Access Compliance Report Public Rights-of-Way (Curb Ramps)

Main Street: EDINGER_AVE Cross Street: HARBOR_BLV Location: SE

ADA ID: RPRK220222154642 Ramp Type: Type 4 - Parallel Initial Pass/Fail: Fail Overall Compliance: No Severity Score: 2

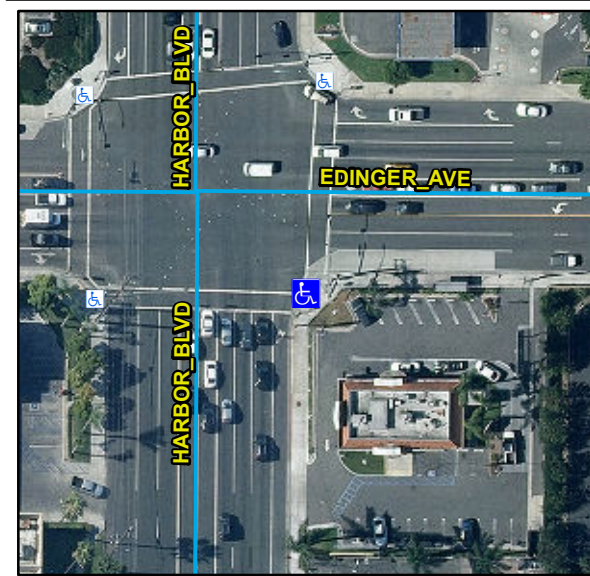
Compliance	Description	Data	Compliance	Description	Data
N/A	Ramp Length LT (in)	87	N/A	Ramp Length RT (in)	84
Yes	Ramp Width LT (in)	132	Yes	Ramp Width RT (in)	132
Yes	Ramp Run Slope LT (%)	5.8	Yes	Ramp Run Slope RT (%)	6.5
No	Ramp Cross Slope LT (%)	4.4	No	Ramp Cross Slope RT (%)	3.9
N/A	Landing Present	N/A	N/A	DWS Provided	N/A
N/A	Landing Length (in)	N/A	N/A	DWS Contrast	N/A
N/A	Landing Width (in)	N/A	N/A	DWS Length (in)	N/A
N/A	Landing Run Slope (%)	N/A	N/A	DWS Full Width	N/A
N/A	Landing Cross Slope (%)	N/A		DWS Offset Type	N/A
N/A	Landing Movement Obstructed?	N/A	N/A	DWS Offset Left (in)	N/A
	Landing Movement Type	N/A	N/A	DWS Offset Right (in)	N/A
N/A	Landing Shared	N/A			
N/A	Clear Space	Yes			
N/A	Clear Space To Crosswalk (in)	48			
N/A	Marked Crosswalk 1	Yes	N/A	Marked Crosswalk 2	Yes
	Crossing 1 Direction	N		Crossing 2 Direction	W
	Marked Crosswalk 1 Width (in)	144		Marked Crosswalk 2 Width (in)	144

Remove & Replace Curb Ramp With Two New Directional Ramps or Equivalent.

R304.5.3, STD 1115
